Meeting of: BUSINESS PARK NORTH COMMITTEE OF THE CITY OF STOUGHTON

- 1. Call to Order
- 2. Elect Chair
- 3. Elect Vice-Chair
- 4. Consider approval on the BPN Committee Minutes of April 13, 2020.
- 5. Request by Edward and Patricia Bierer of Stellar Services for approval of a building addition at 301 Business Park Circle.
 - Recommendation to Plan Commission
- 6. Future agenda items.
- 7. Adjournment.

I have completed a final review of the proposed building addition/site plan for Stellar Services, LLC., 301 Business Park Circle. This item is planned to be on the Plan Commission and Business Park North agendas for May 11, 2020 of which you will receive notice. This project is also subject to the Business Park North Covenants as outlined below. As noted, additional information may be required to be provided or shown on the plan.

Exterior Elevations Scale: 1/8"= 1'-0'

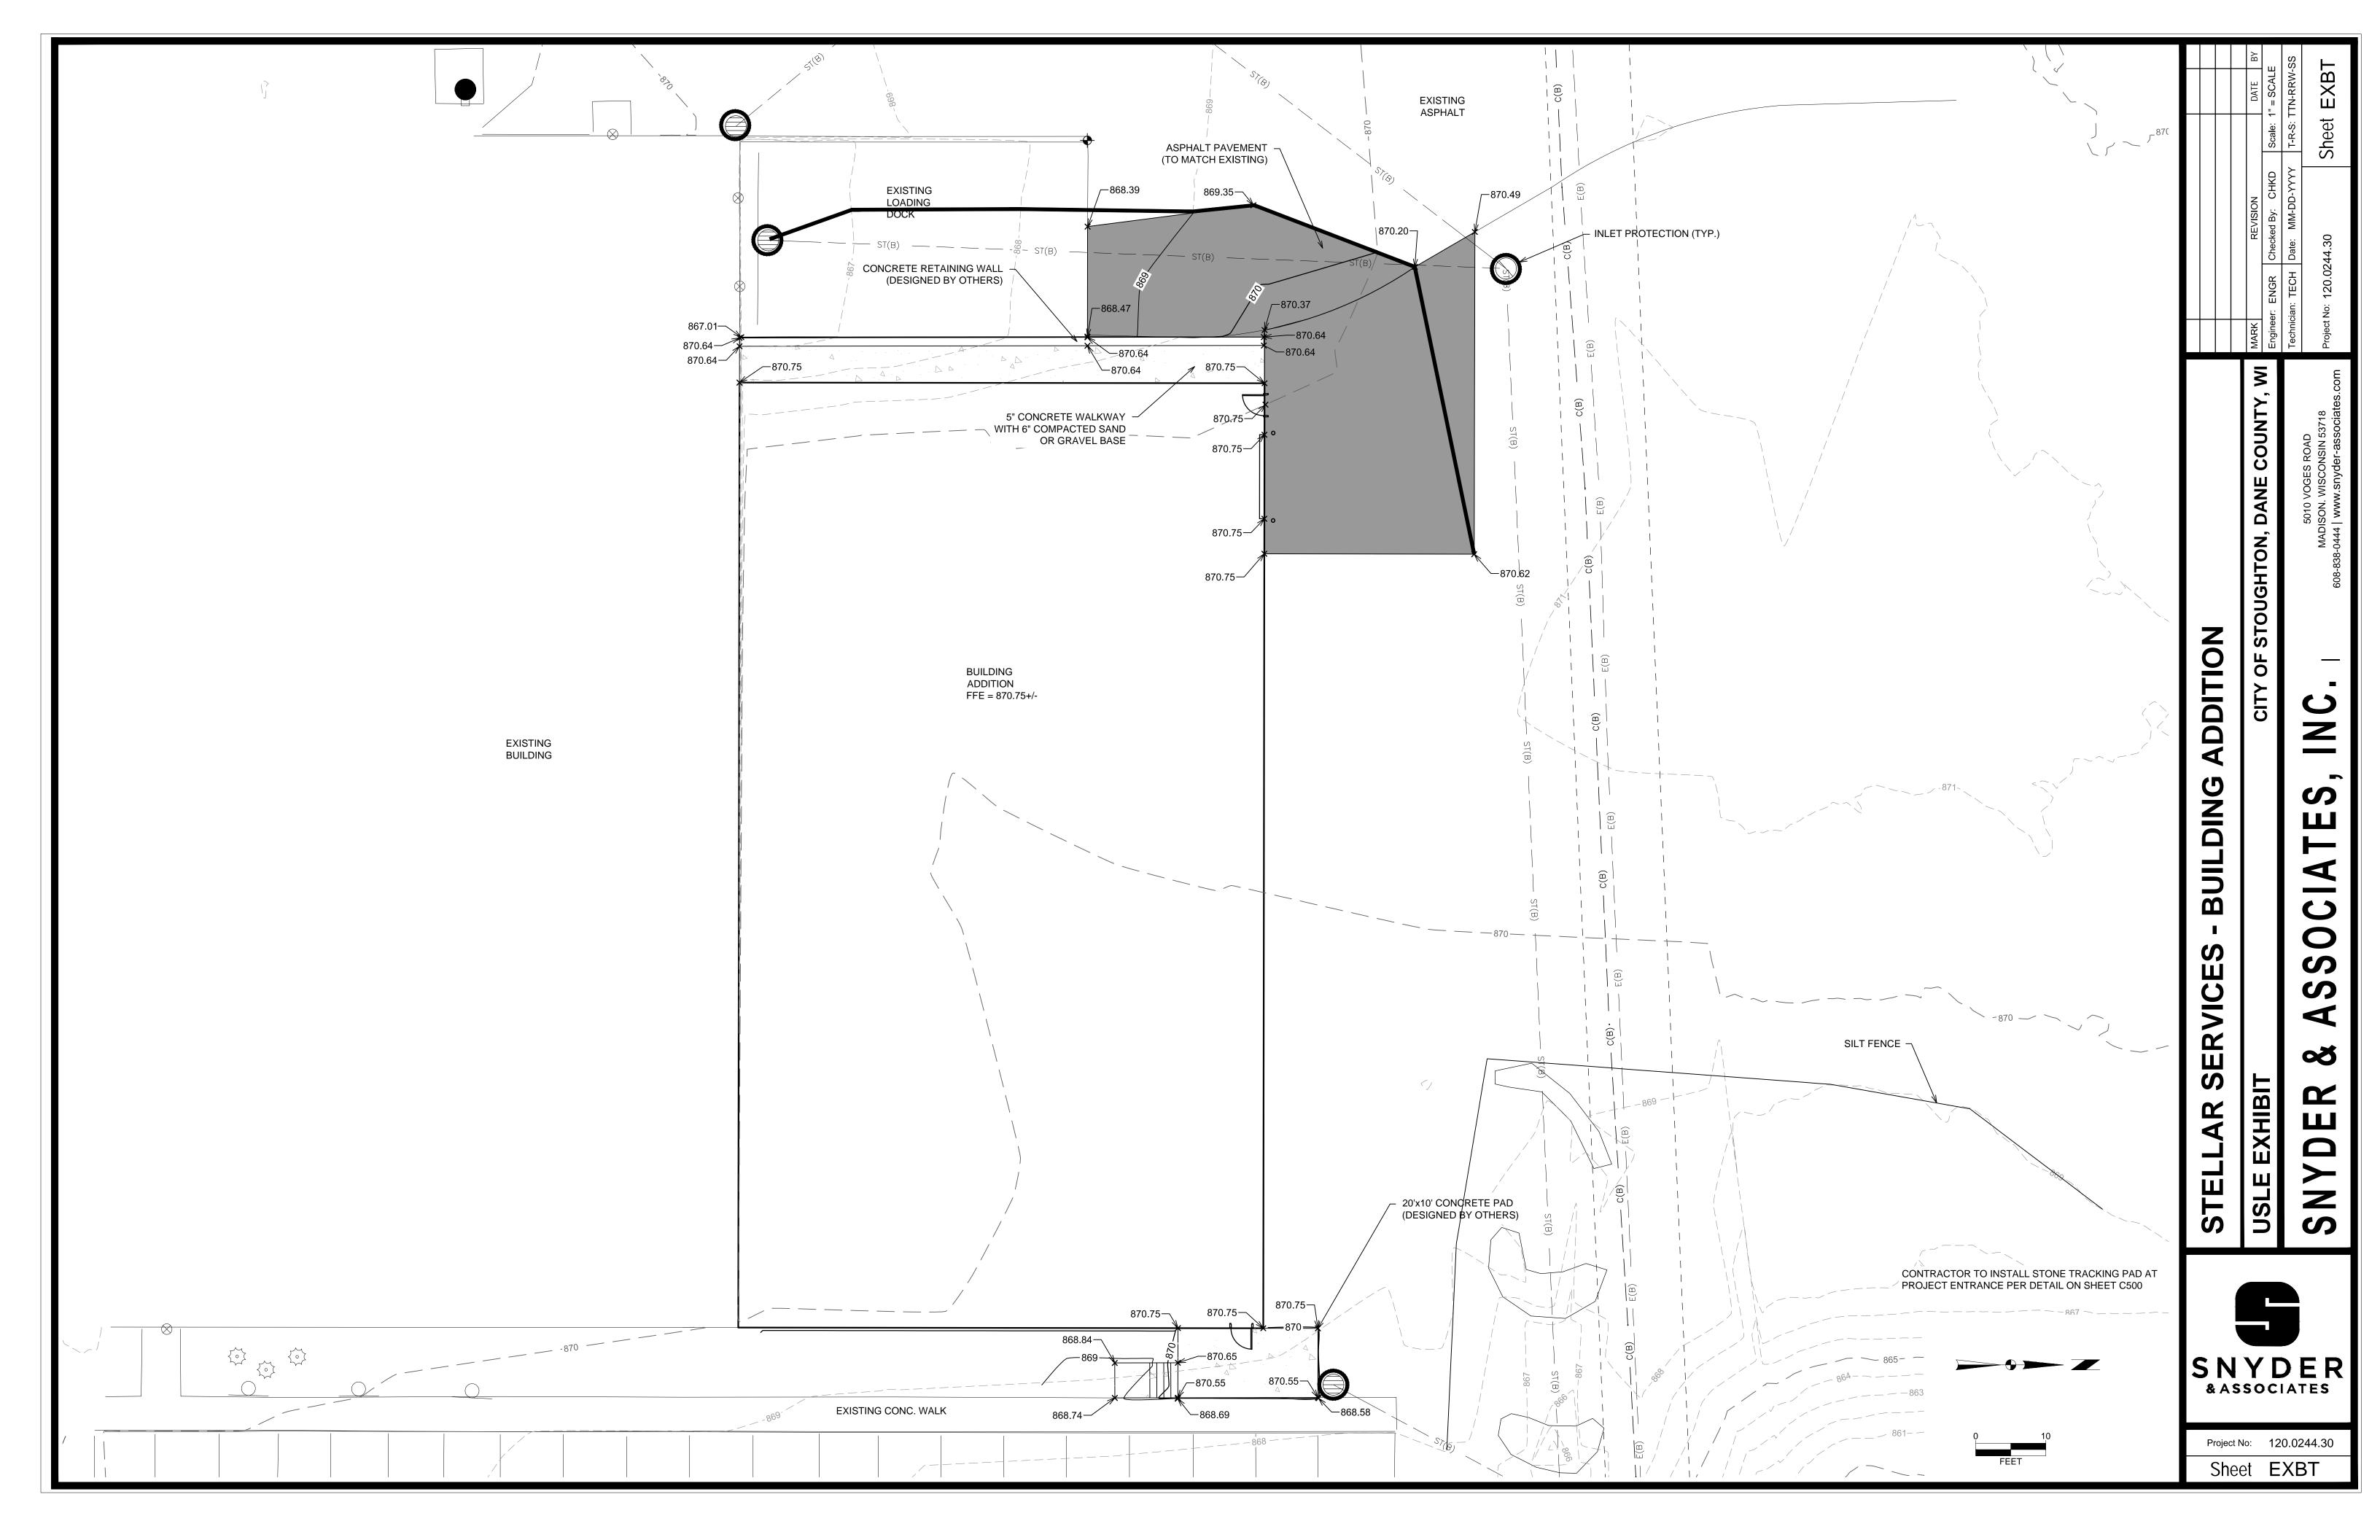
- a. The front facade and street-side facades shall include brick, stone, architectural concrete panels, architectural metal, architectural wood and/or glass. Unfaced concrete block, structural concrete, prefabricated metal siding, and the like are discouraged from such facade areas. The use of these materials shall only be in a manner approved by the Committee. Special consideration will be exercised for structures built on a corner lot. This is a corner lot so consideration should be given in requiring all frontages to be brick.
